# Addendum No. Two

RFP No: FY24-805-45 A

Airport Terminal Building Improvements AWIP : BHS-TC2/TC4 : A-Wing Offices

This Addendum # 2 to Request for Bids for Airport Terminal Building Improvements AWIP : BHS-TC2/TC4 : A-Wing Offices contains the following responses to bidder inquiries and clarifications or changes to the Bid Documents:

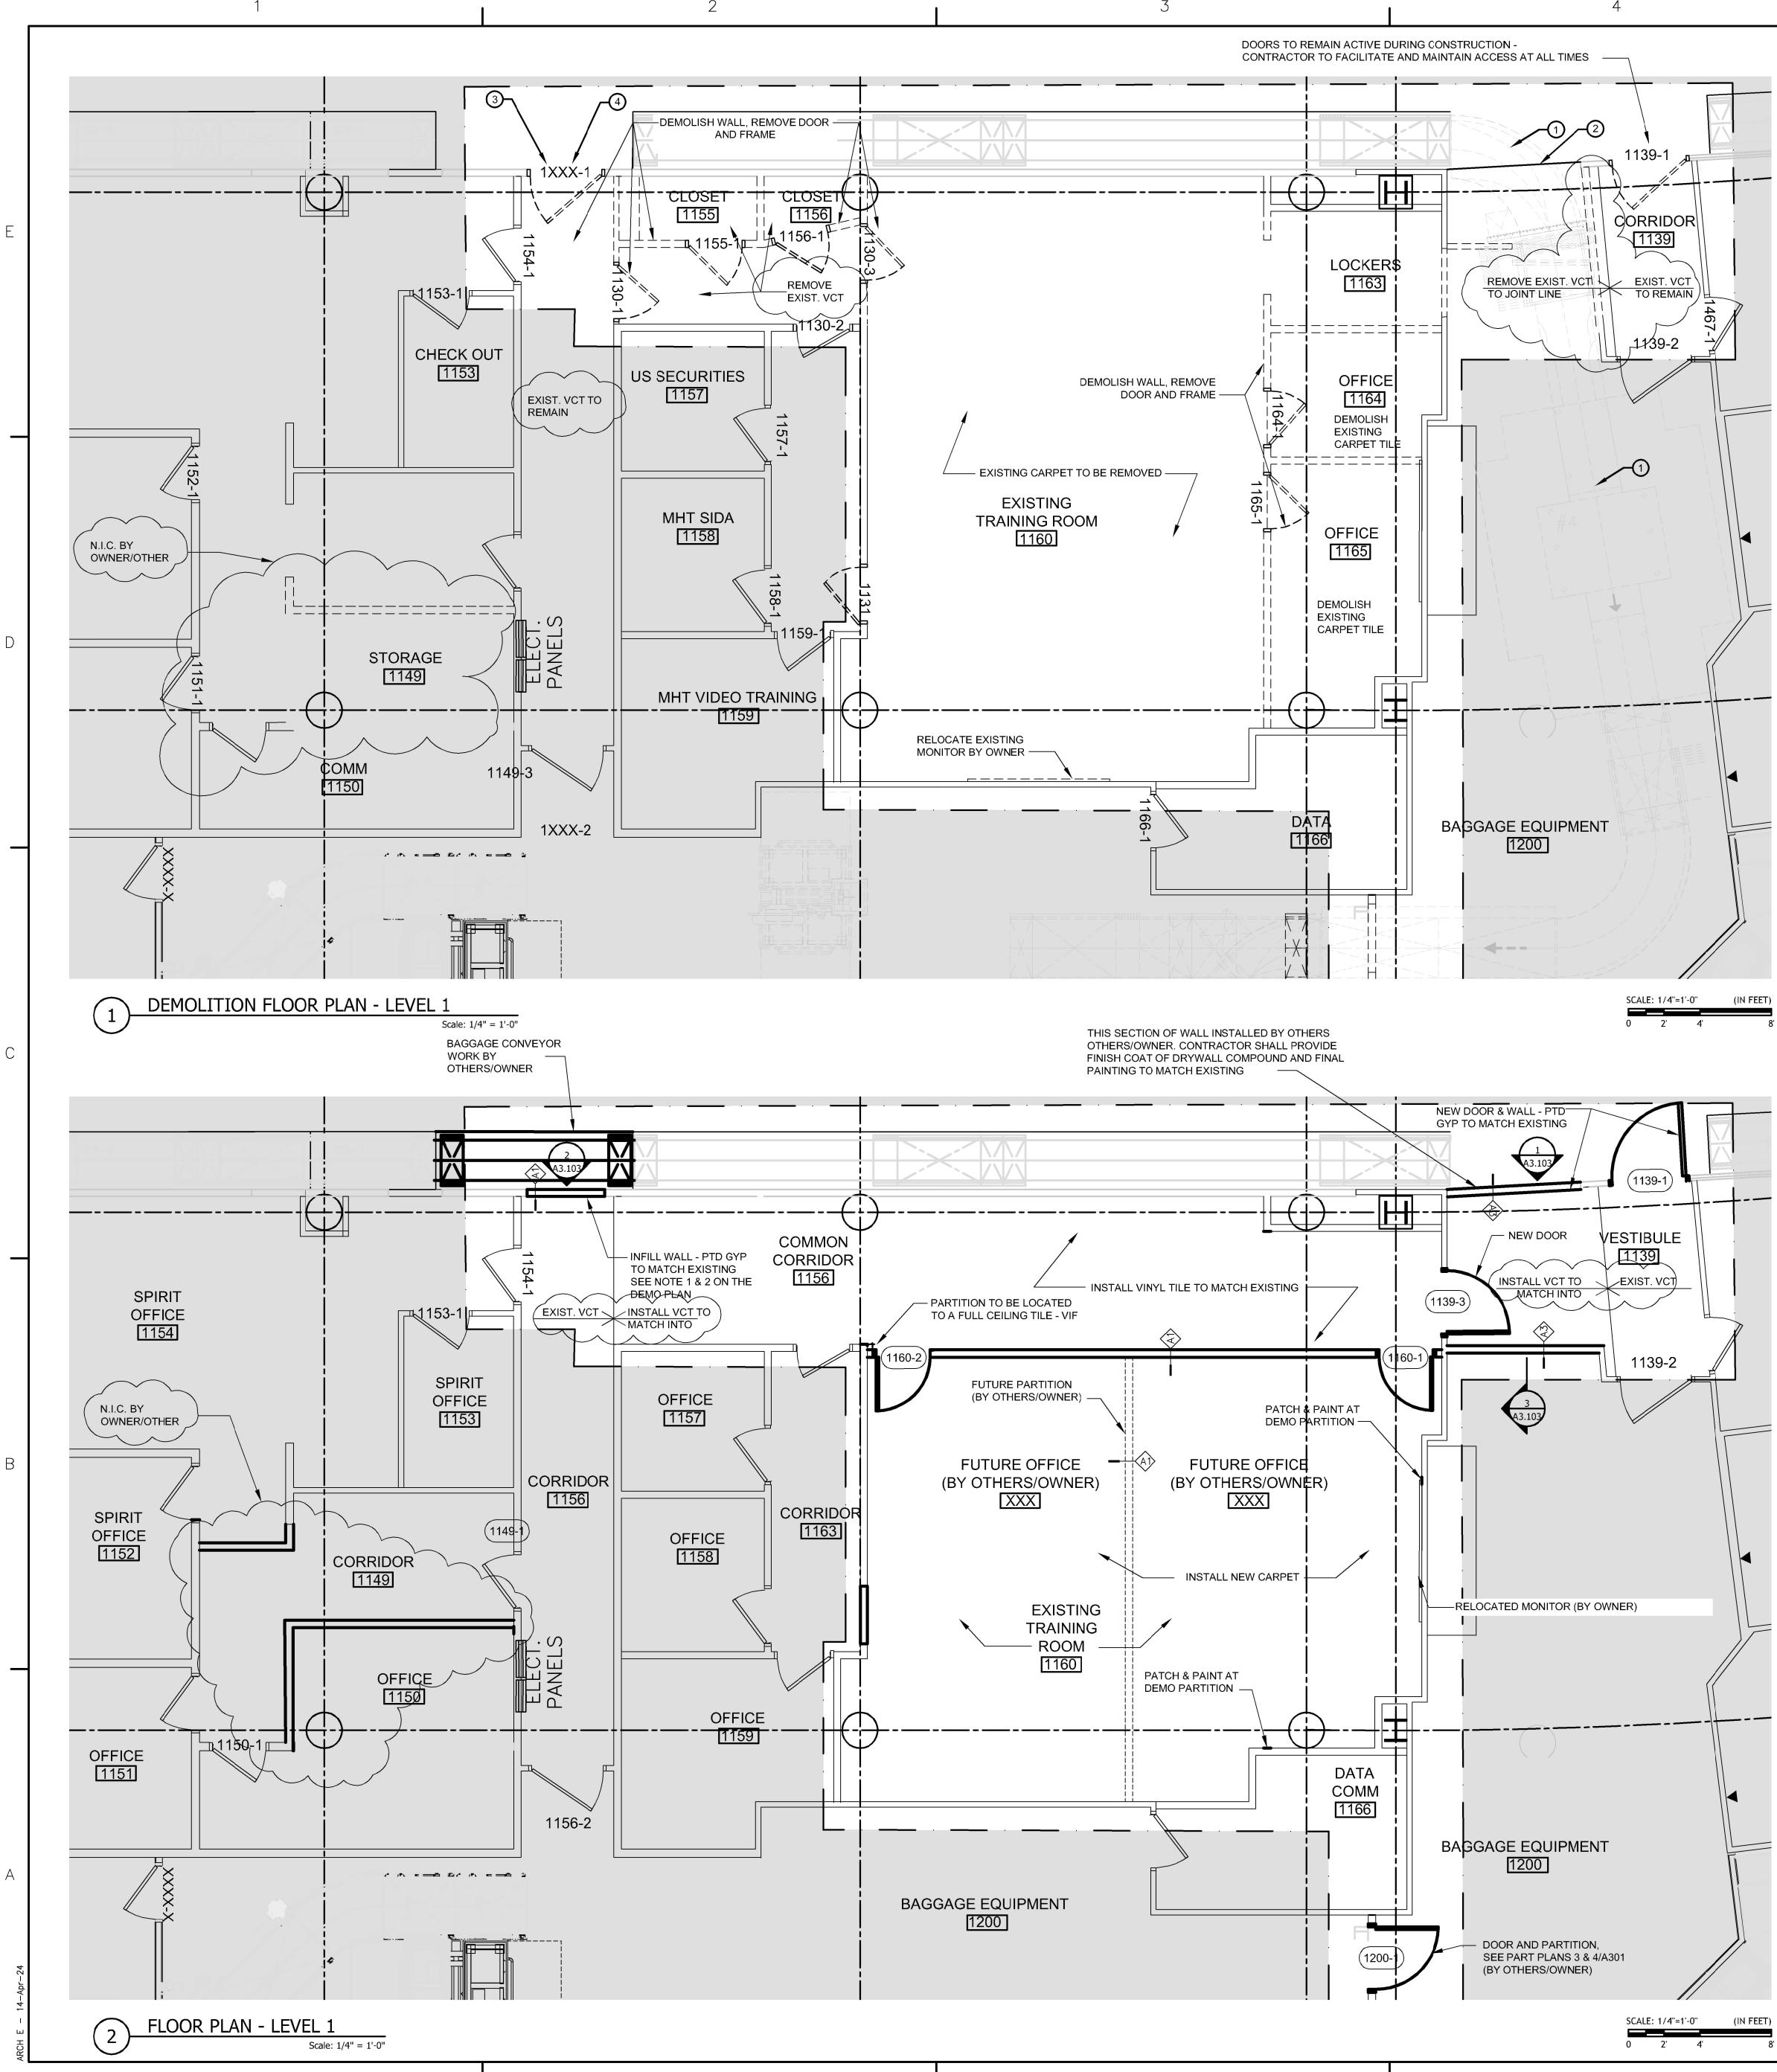
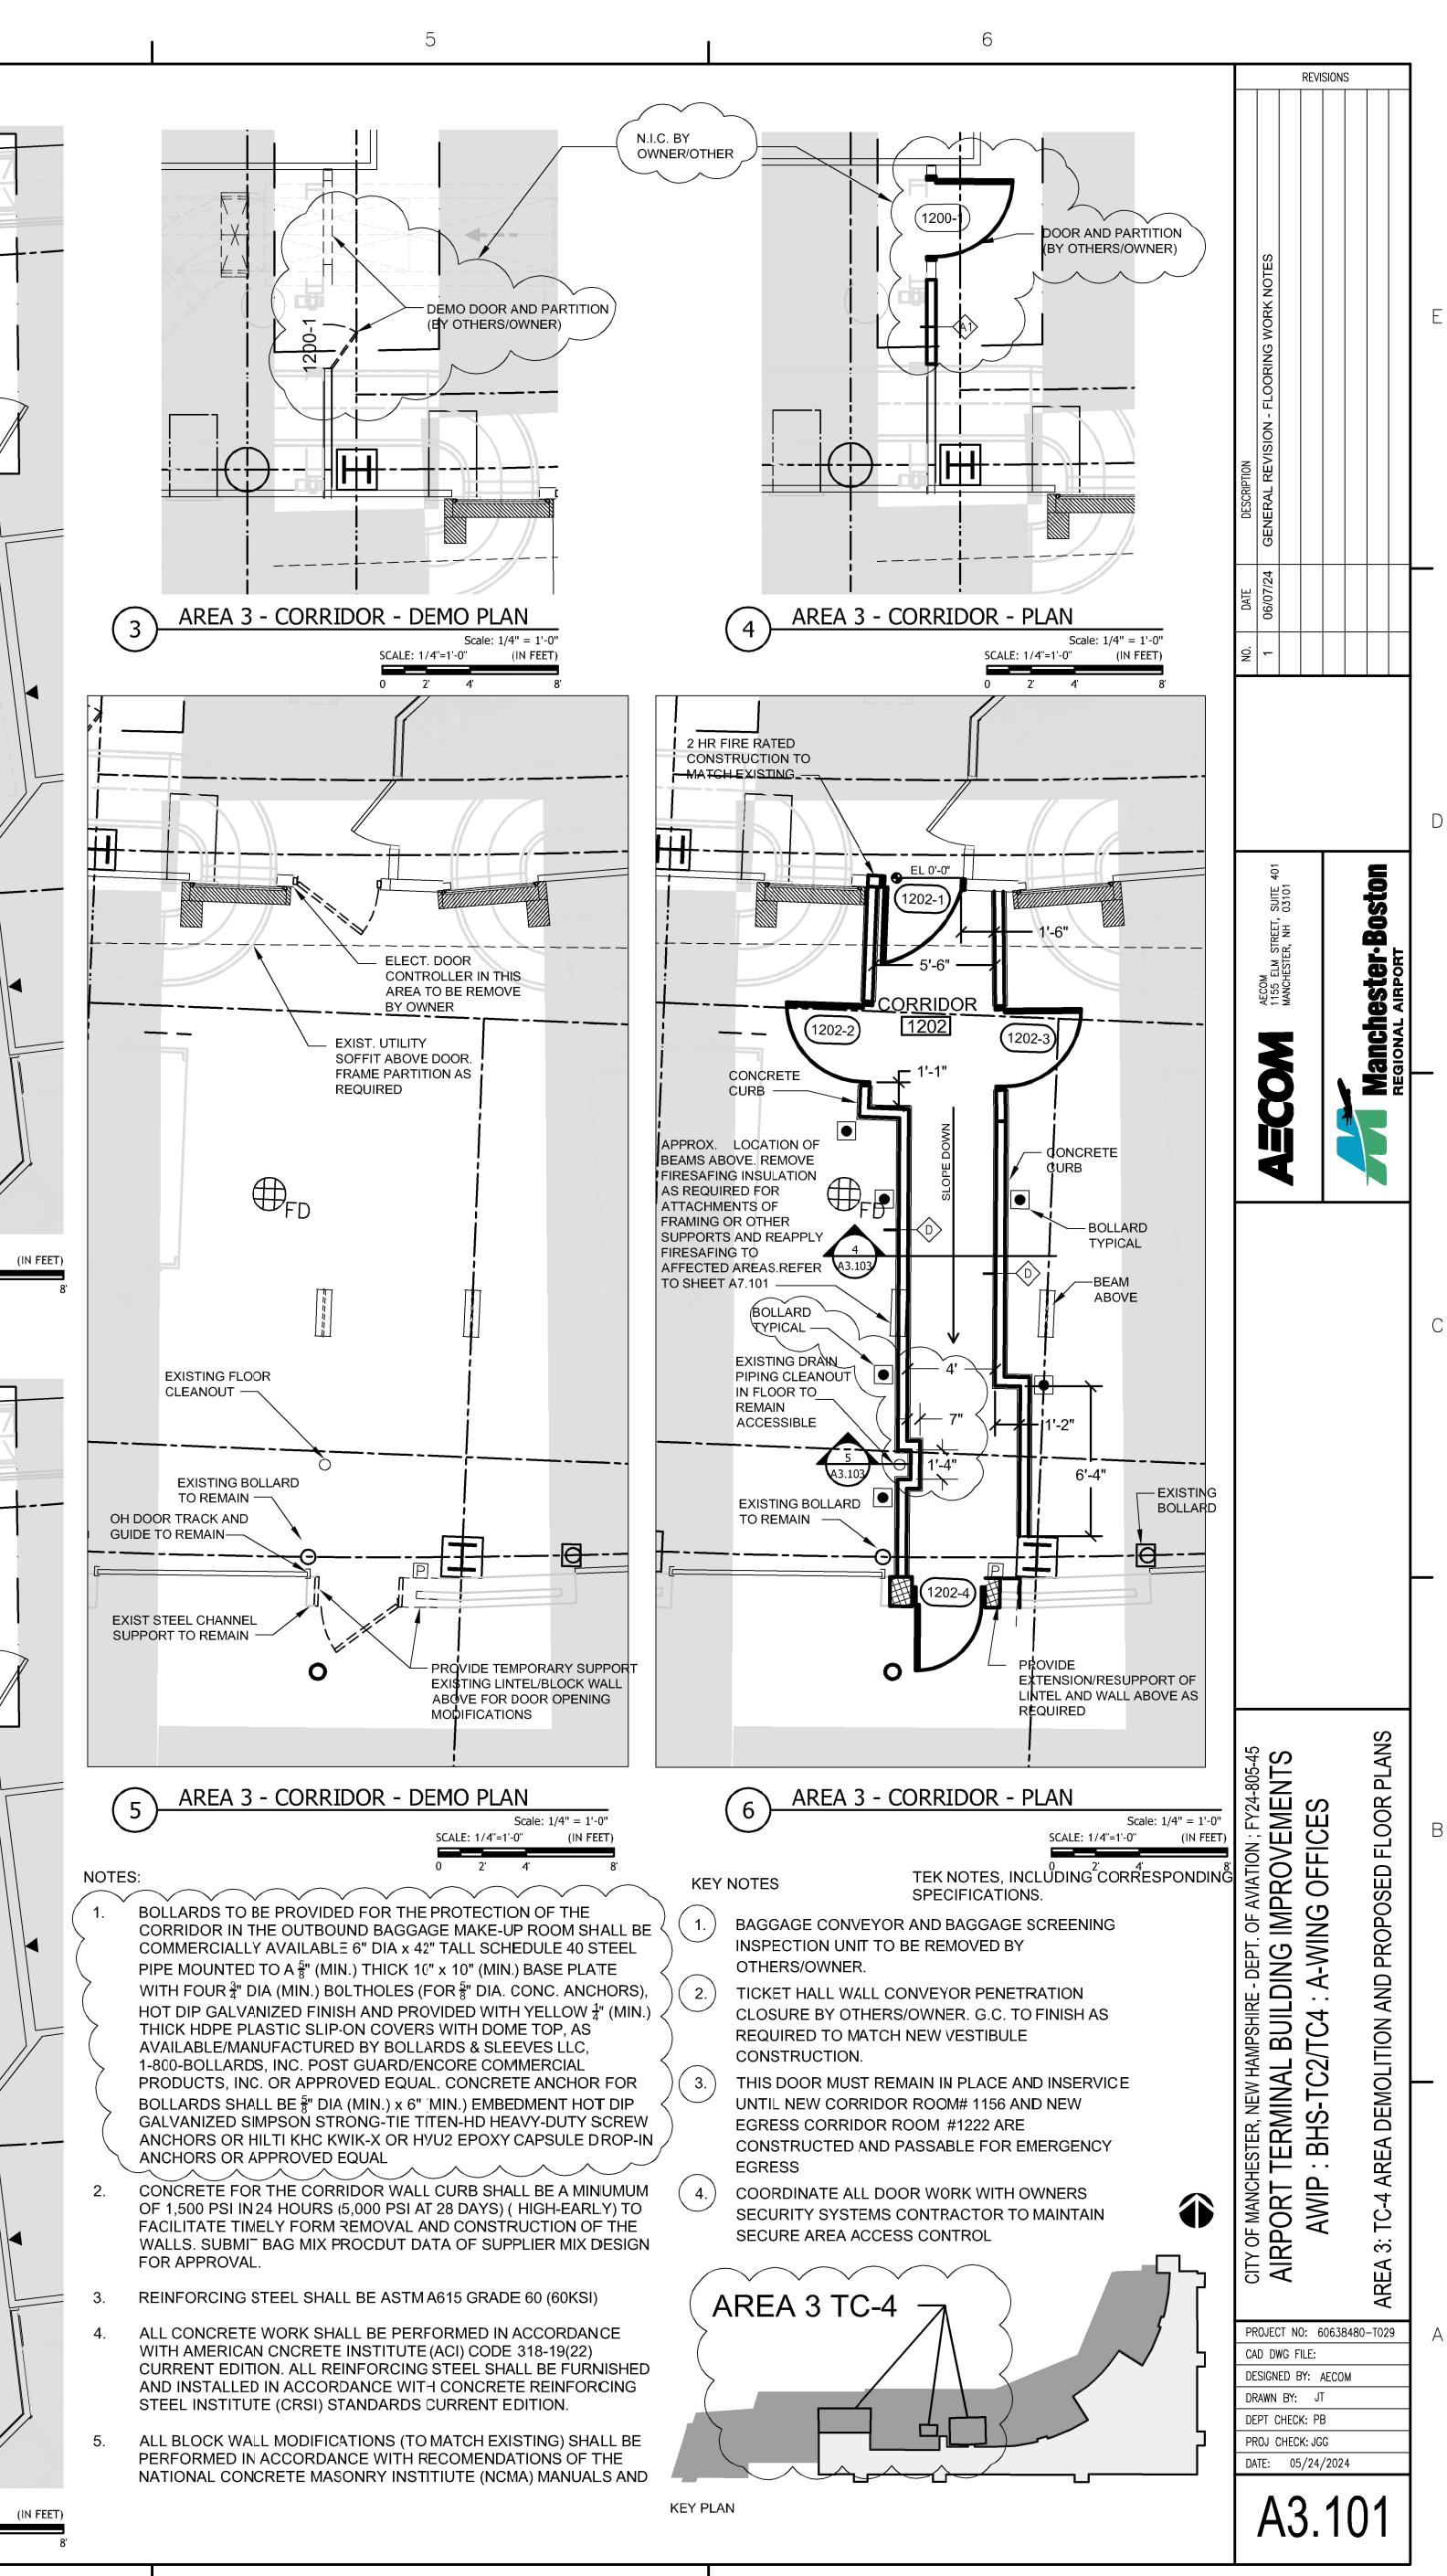
1	BAGGAGE CONVEYOR AND BAGGAGE SCREENING INSPECTION UNIT TO BE REMOVED BY OTHERS
2	TICKET HALL WALL CONVEYOR PENETRATION CLOSURE BY OTHERS. CUT NEW OPENING AND RE-FRAME AS REQUIRED FOR NEW DOOR OPENING
